Addendum No. 3 to IFB 16-48

To: All Parties on Record with the City of Somerville as Holding **IFB 16-48**
Cedar St Sewer Separation

Re: Extended Due Date, Revised Unit Price Form, Updated Specifications, Select, Revised Drawings/Plans

PROPOSED TEMPORARY HOT MIX ASPHALT PATCH FOR TRENCH:

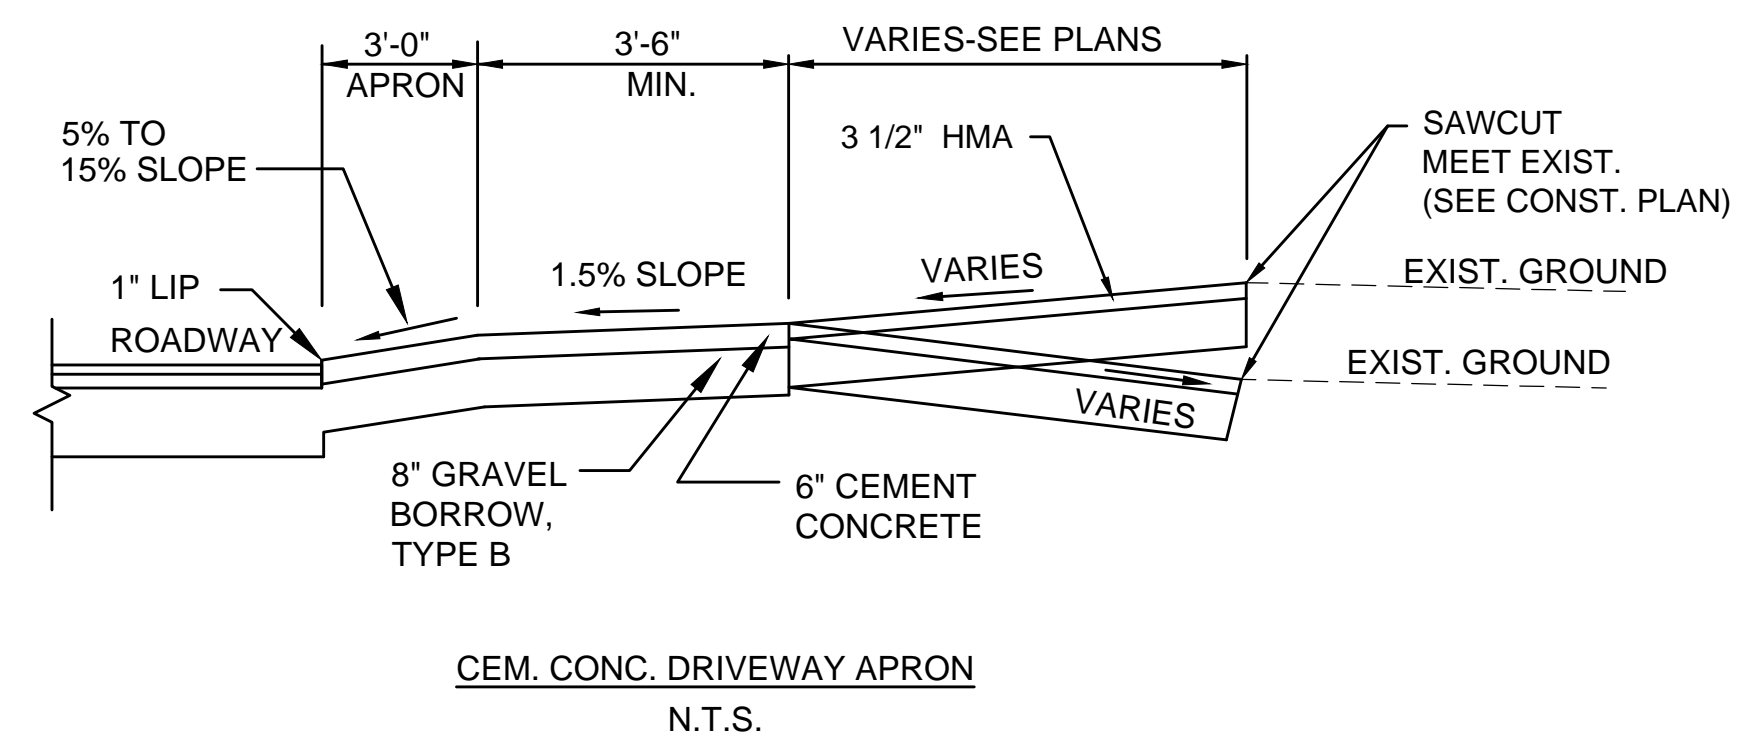
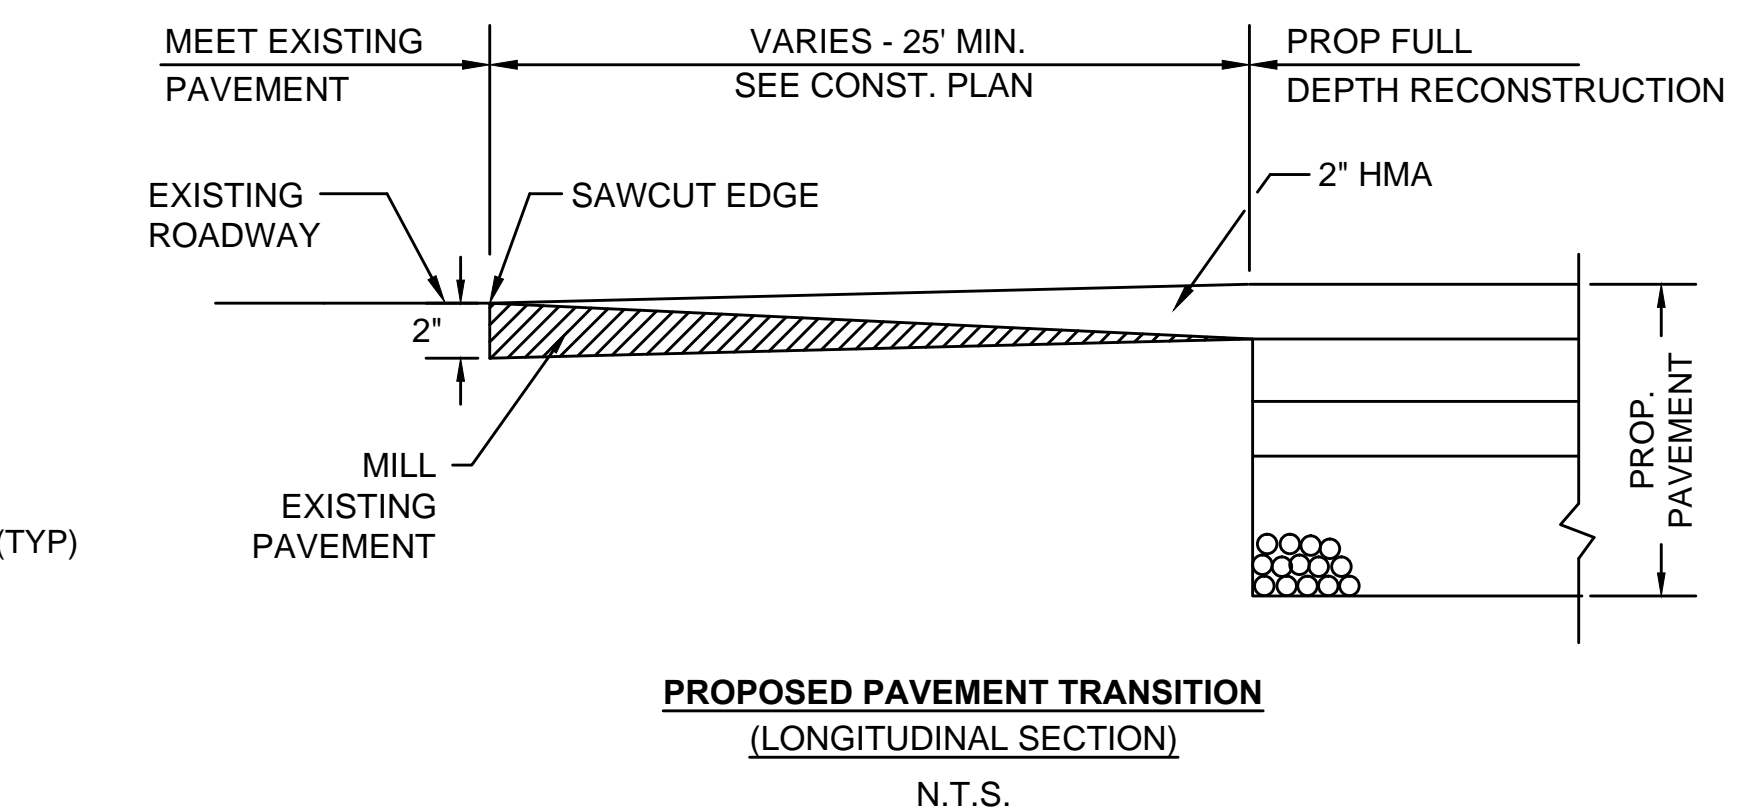
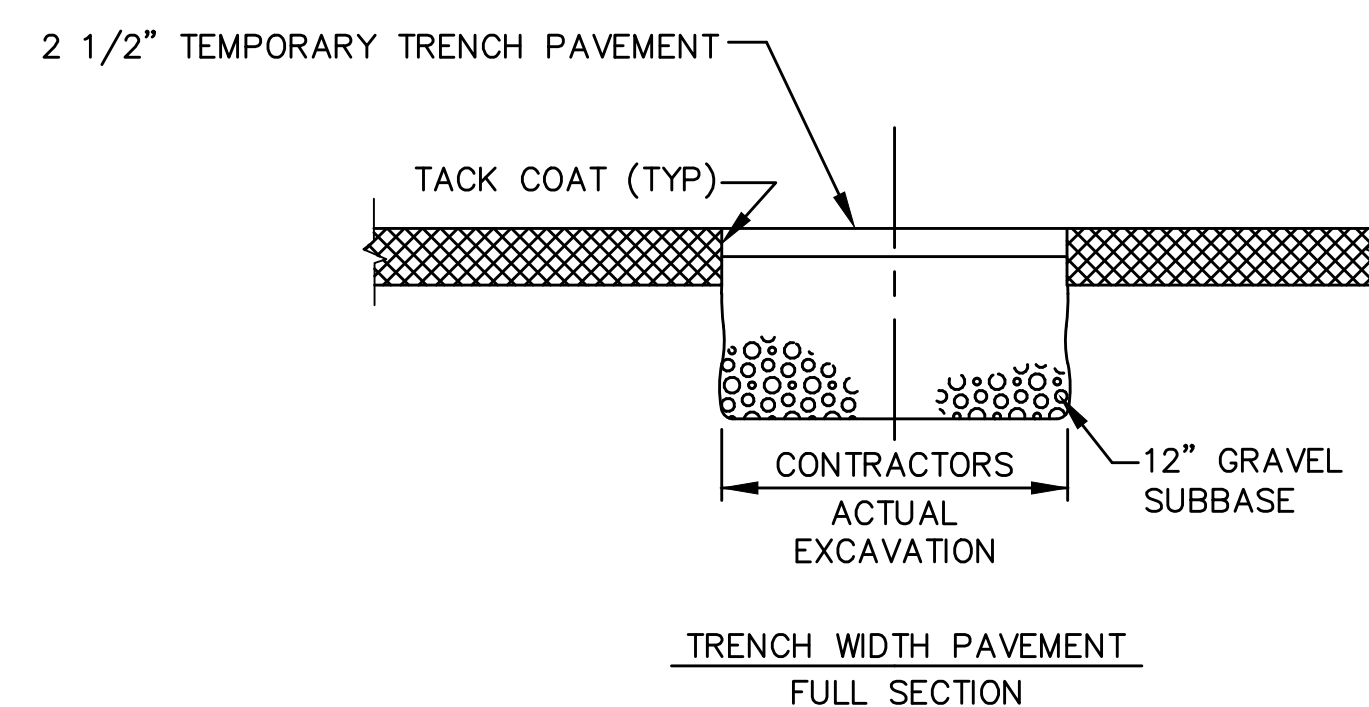
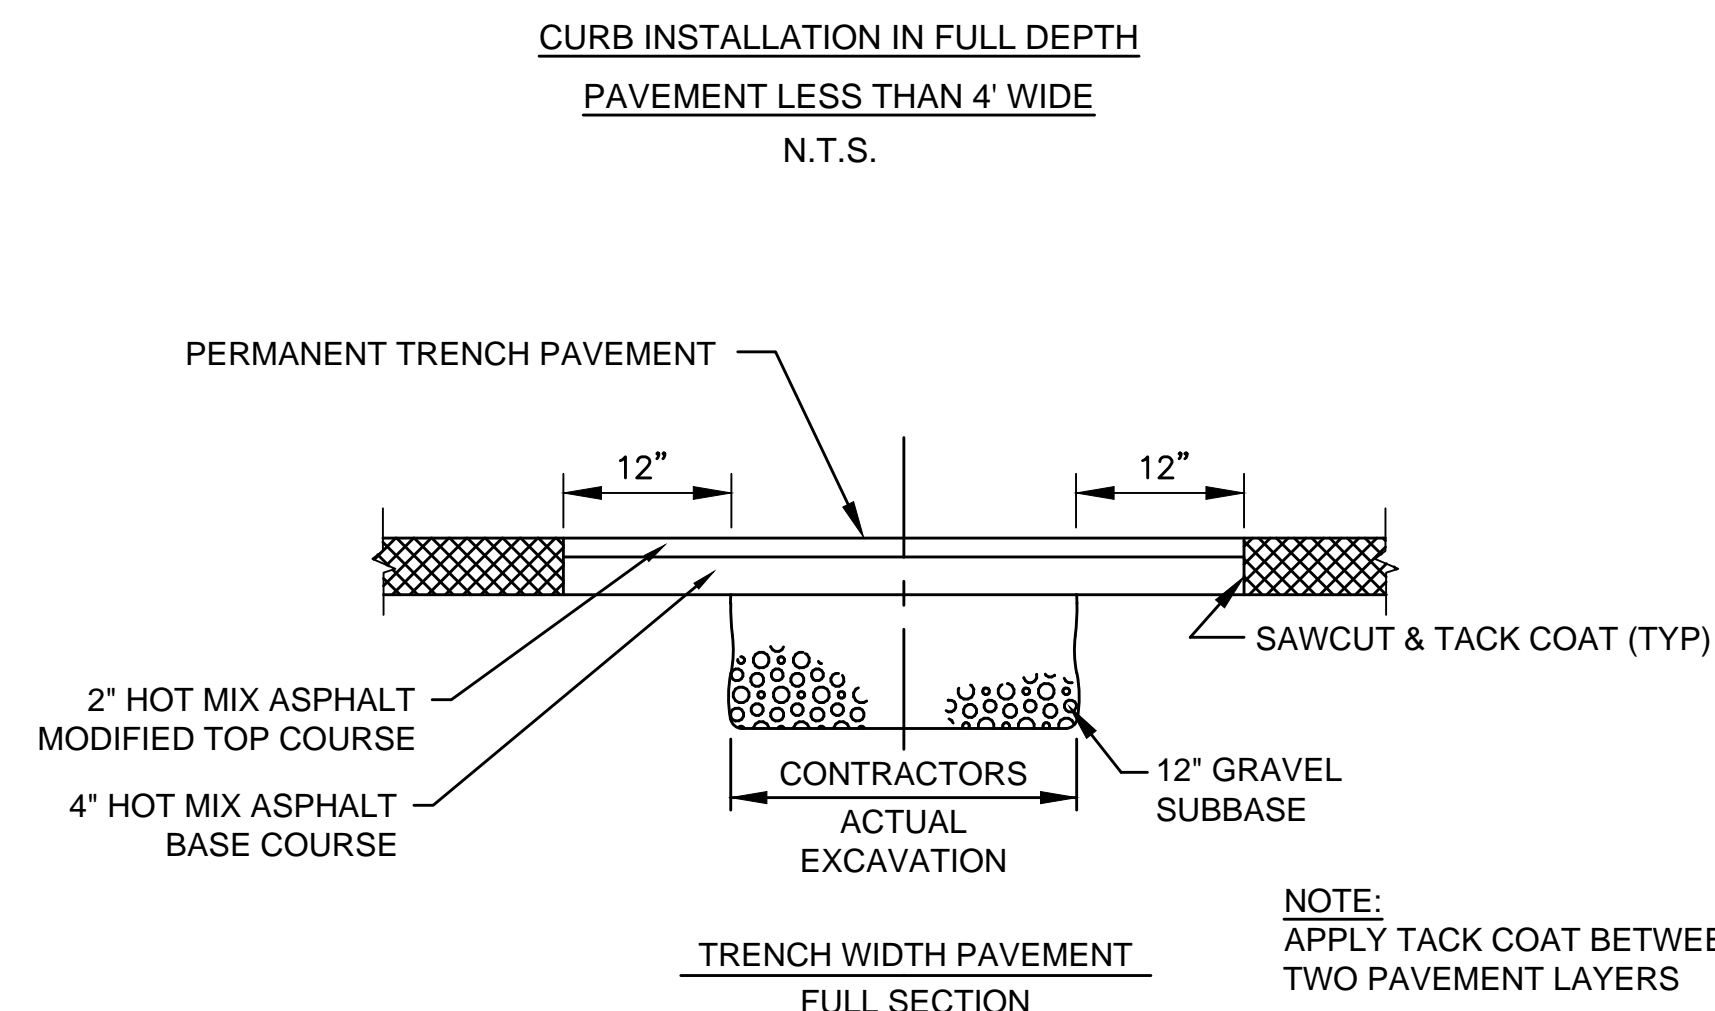
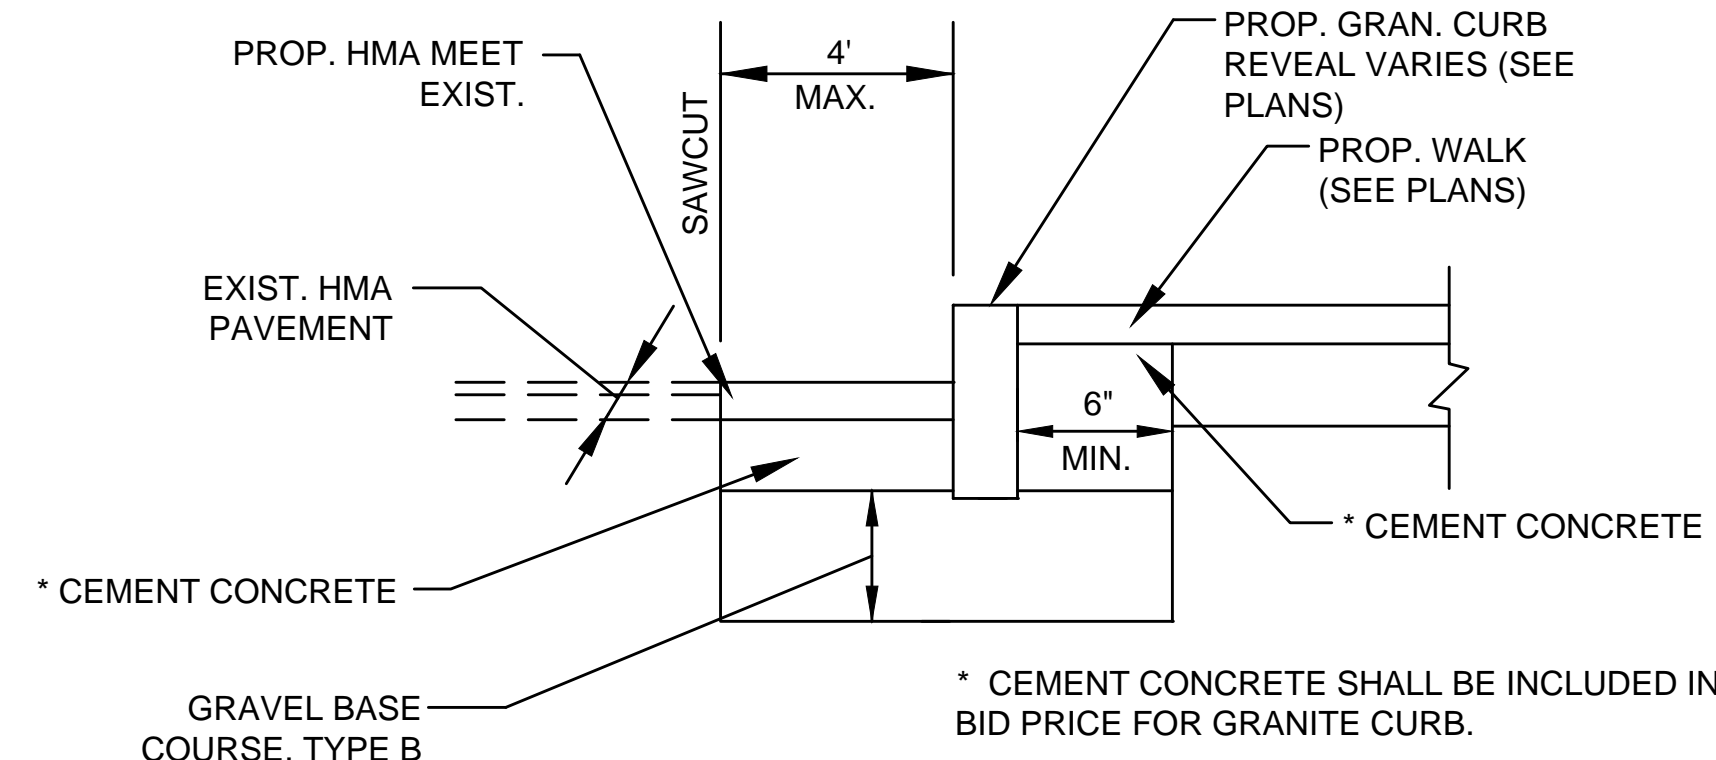
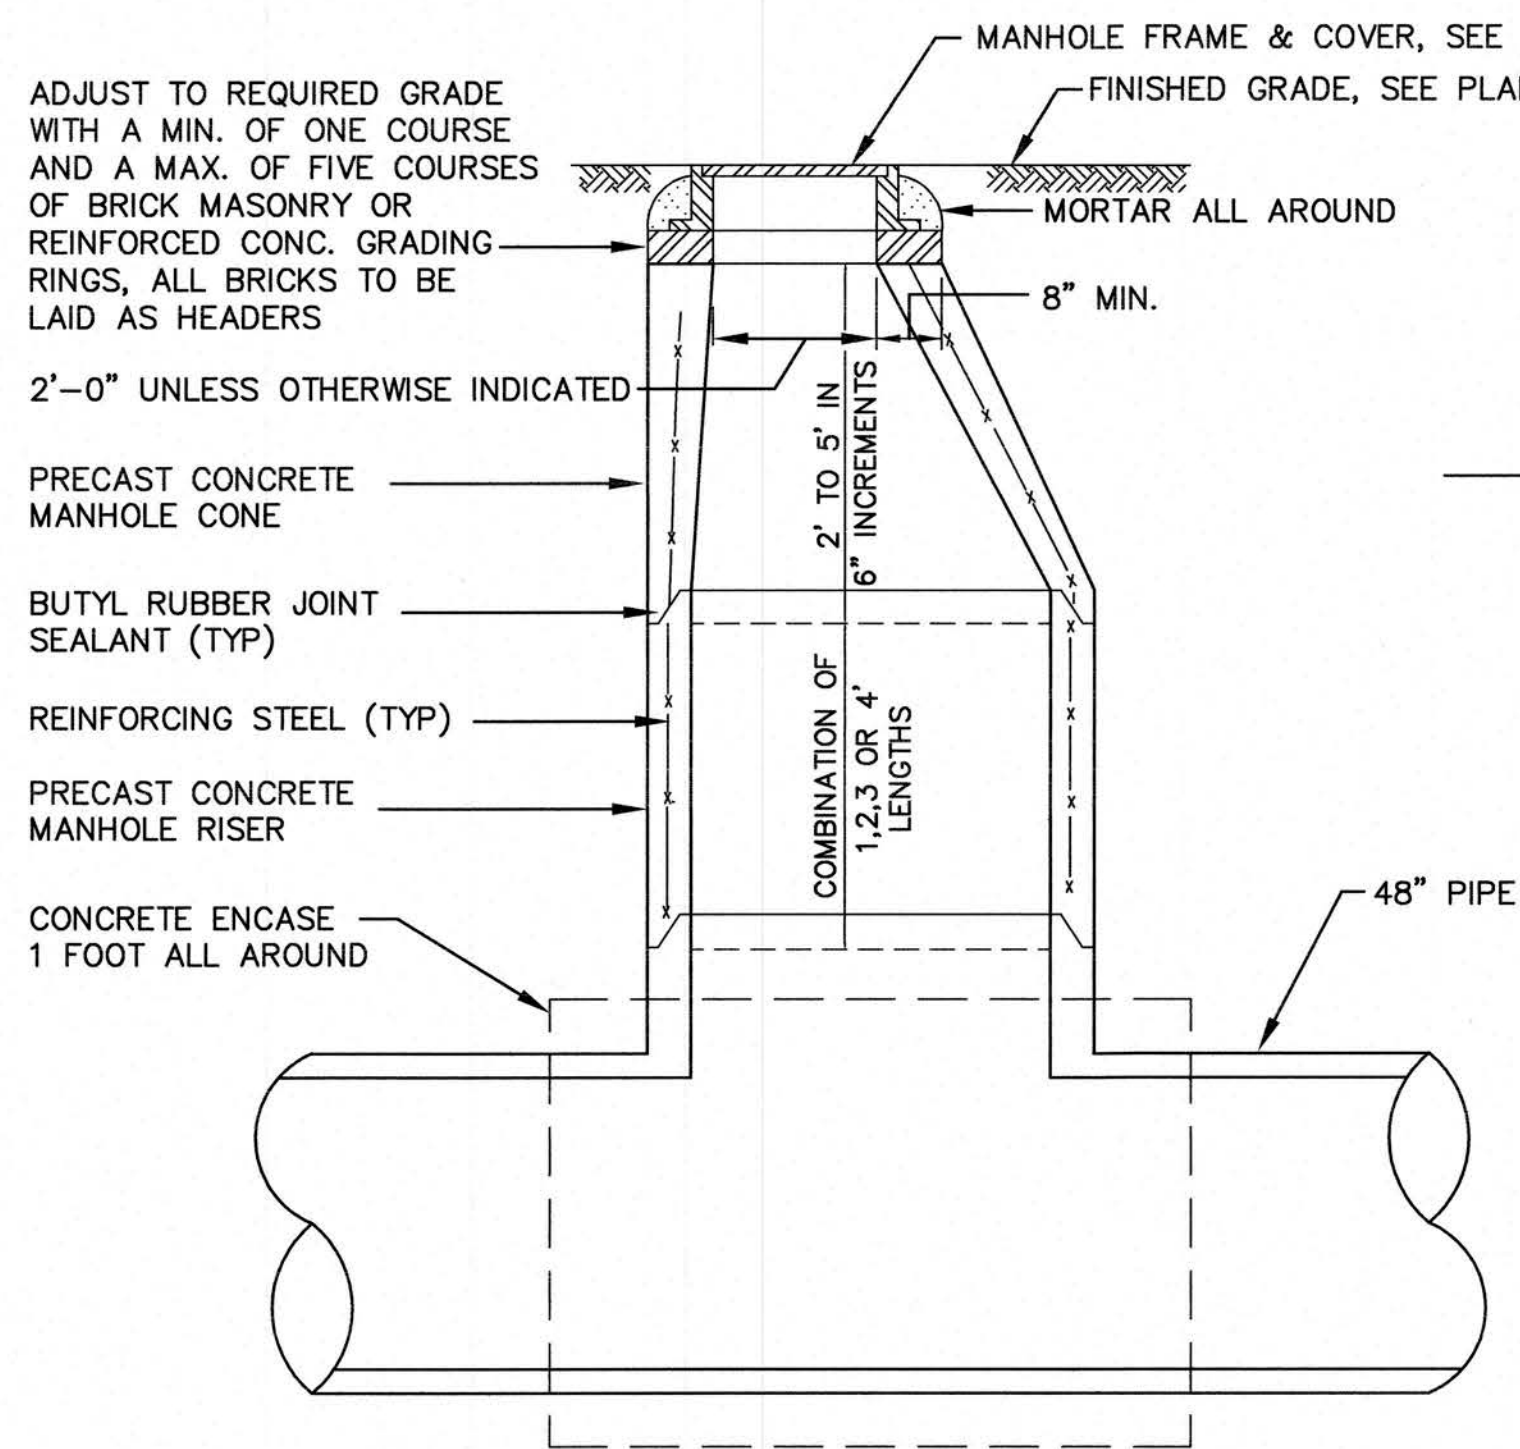
Q: Drawing D-1 temporary pavement/trench detail shows 2-½” of temporary pavement but the paving notes on the sheet states 1” temporary pavement. Please clarify.

Q: There are no details for the trench paving/restoration of Elm Street; please clarify.

A: The Pavement Notes have been updated to show 2-1/2” of “Temporary Hot Mix Asphalt Patch for Trench”

A: The Elm Street Permanent Trench Pavement Replacement Detail was added to the construction details on Sheet D-1. The revised plans are attached herein (Attachment 3).
